TRANS/WP.29/GRE/2001/7
19 February, 2001

World Forum for Harmonisation of Vehicle Regulations (WP.29)

Working Party on Lighting and Light-Signalling (GRE)
(Forty-sixth session, 27-30 March, agenda item 2.6.)

PROPOSAL FOR DRAFT SUPPLEMENT 1 TO THE DRAFT REGULATION:

OVERVIEW OF OPERATIONAL PERIODS
CONCERNING TEST FOR STABILITY OF PHOTOMETRIC PERFORMANCE

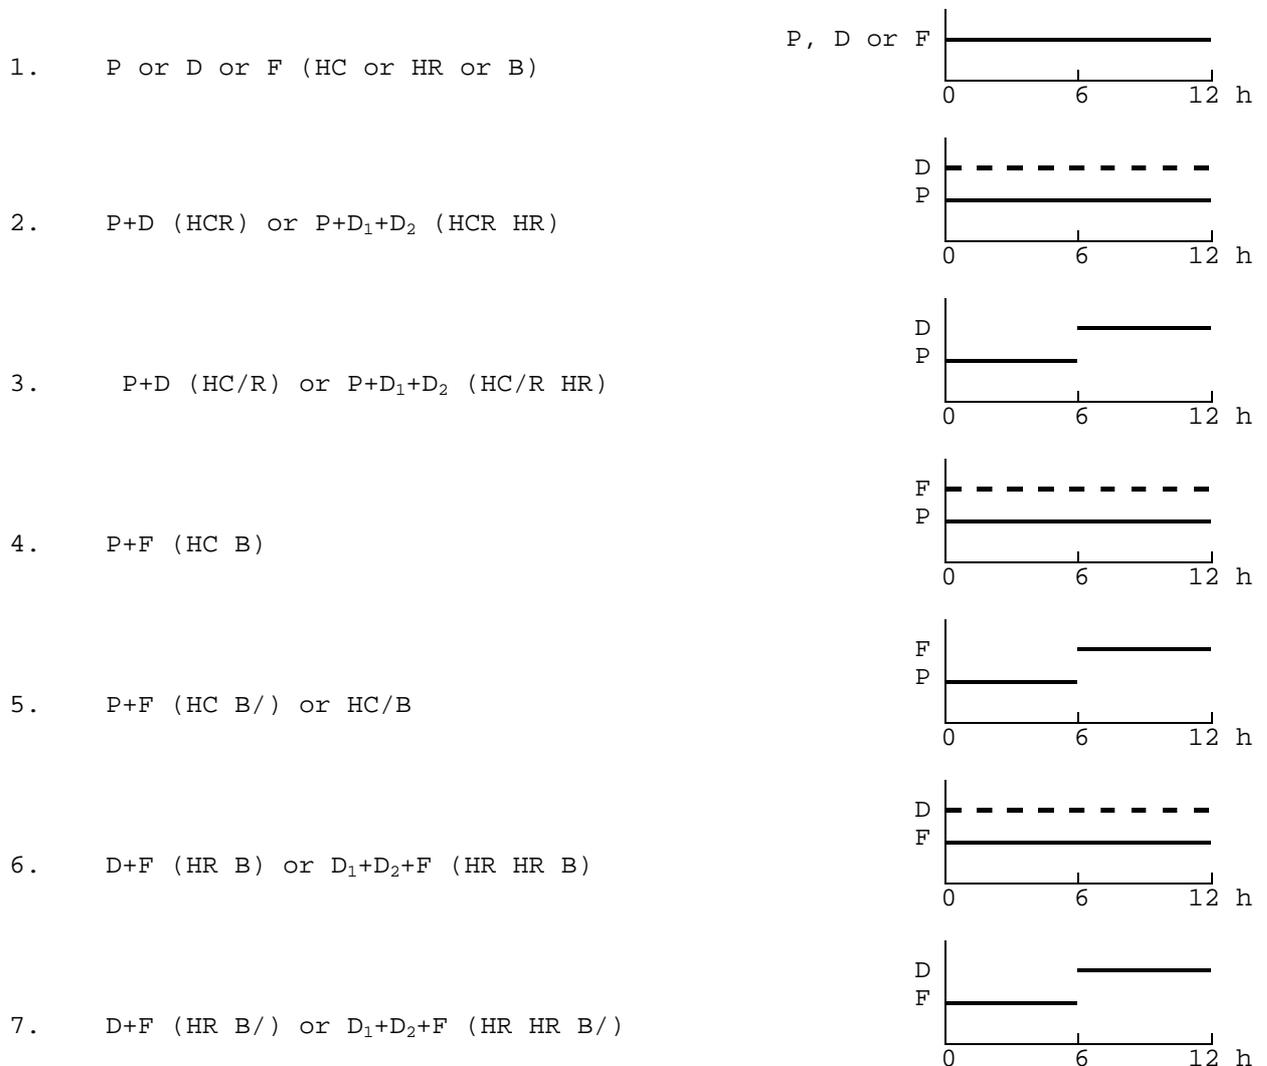
Add a new Annex 8, to read:

Abbreviations: P: passing beam lamp

D: driving beam lamp (D₁ + D₂ means two driving beams)

F: front fog lamp

----- : means a cycle of 15 minutes off and 5 minutes lit.
